**PERMIT**  
 INDEXED  
 TAX ID #05-384710  
**ON-SITE SEWAGE DISPOSAL SYSTEM**  
**HOWARD COUNTY HEALTH DEPARTMENT**  
**BUREAU OF ENVIRONMENTAL HEALTH**

SUBDIVISION: Allnutt Farms Estates LOT NUMBER: 14

ADDRESS: 13492 Open Space Court PROPERTY OWNER: Steve Allnutt

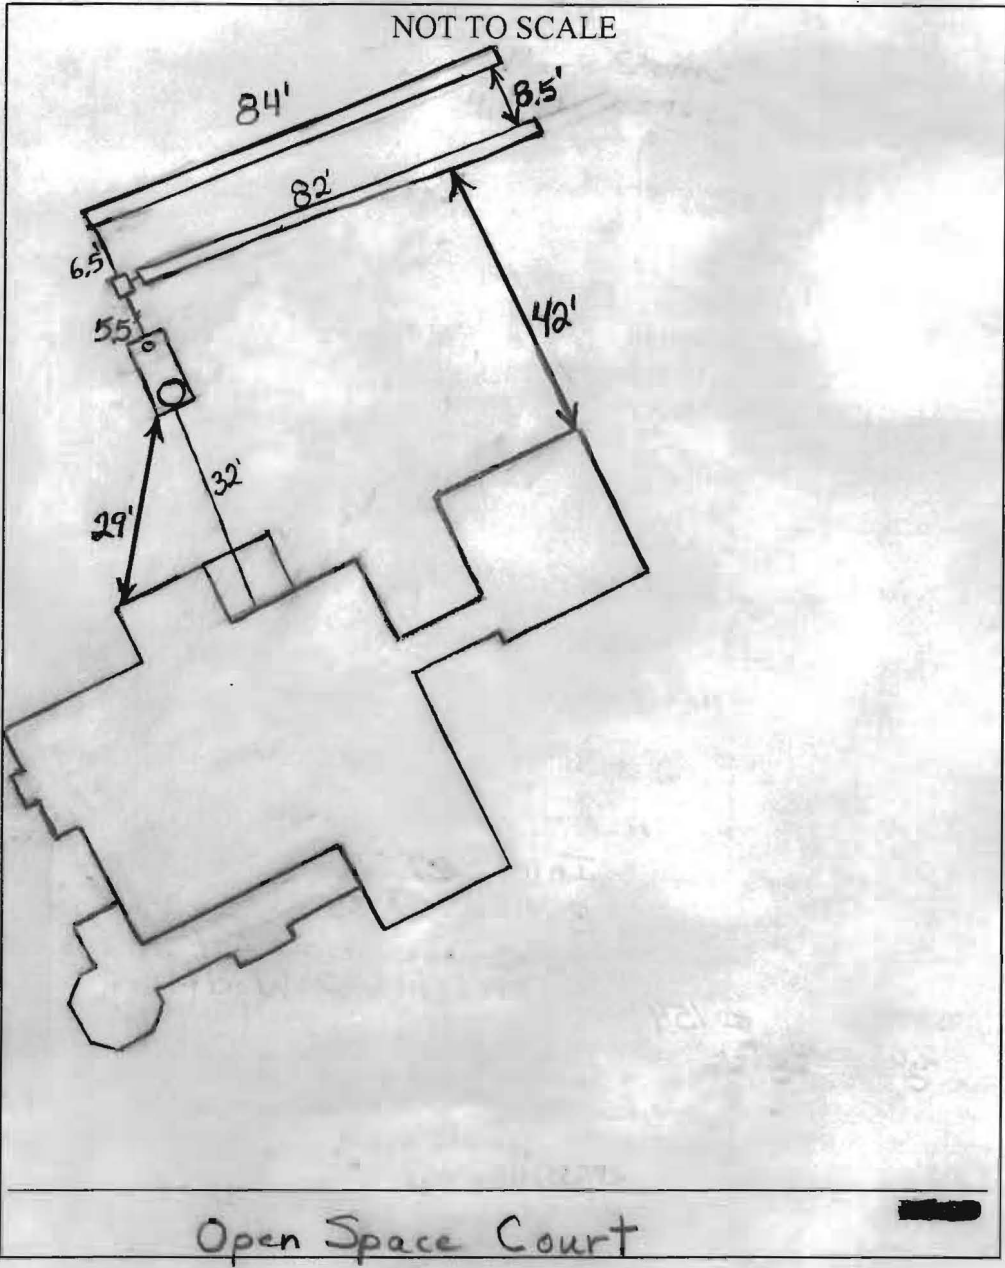
*Inlet 2.5'*  
*Bottom 7.5'*  
*5' Stone Below Pipe*  
*Trenches 2' Wide*

TRENCHES:	Trench to be <sup>2.0'</sup> <del>3.0</del> feet wide. Inlet 3.0 feet below original grade. Bottom maximum depth 7.0 feet below original grade. Effective area begins at 3.0 feet below original grade. 4.0 feet of stone below distribution pipe.
LOCATION:	Place the distribution box at the highest elevation in the approved SDA.
NOTES:

2/24/06 Fill on top of easement. Remove and call for another

INSTALLATION layout. Install 2 - 77' trenches across top of

easement. See changed trench specs. (BB) 3/8/06 Tank set

TRENCH/DRAINFIELD DATA		
WIDTH	INLET	BOTTOM
2	2.5'	7.5'
NUMBER OF TRENCHES		2
TOTAL LENGTH		166'
ABSORPTION AREA		830
DISTRIBUTION BOX LEVEL		Levelers
DISTRIBUTION BOX BAFFLE		Yes
DISTRIBUTION BOX PORT		No
